PCN Reference: LFPCN230428

Subject: Inner box packing Label update for Medium Power modules

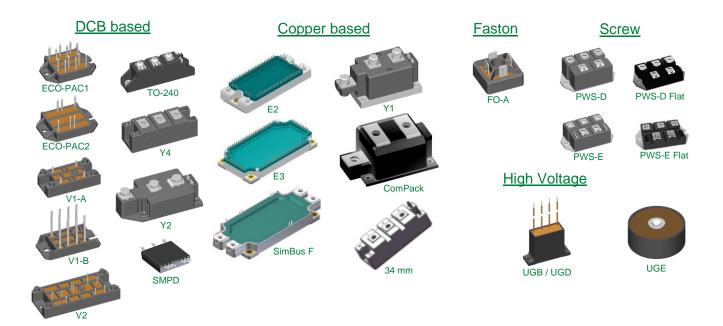
Littelfuse would like to notify you about implementing inner packing box label change for its **Medium Power Modules** built in our different assembly locations.

To harmonize the marking, we will remove Pb-Free marking which is not relevant to all our products portfolio and will only show up a "RoHS compliant" logo which is appropriate to all our power modules.
